Class II Change Letter

Product Name: Barcode Scanner
FCC ID: HD5-8680B
Model No.: 8680i

8680i (Seychelles)
Main PCB Assembly

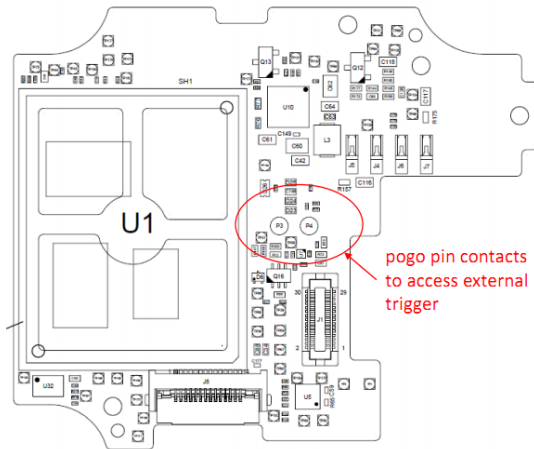
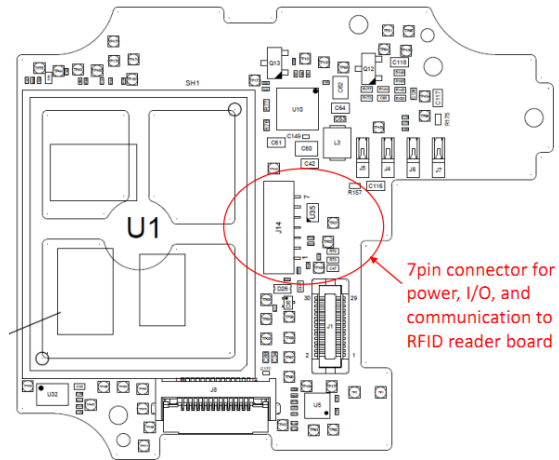
1. Modified bottom housing to expose Interface Connector RFID reader not shown

We re-evaluated Spurious emission and output power of this modified product, and the values are lower than original application, so we considered it as C1PC, the reason we apply for this C2PC is that SAR value need to be recalculate.
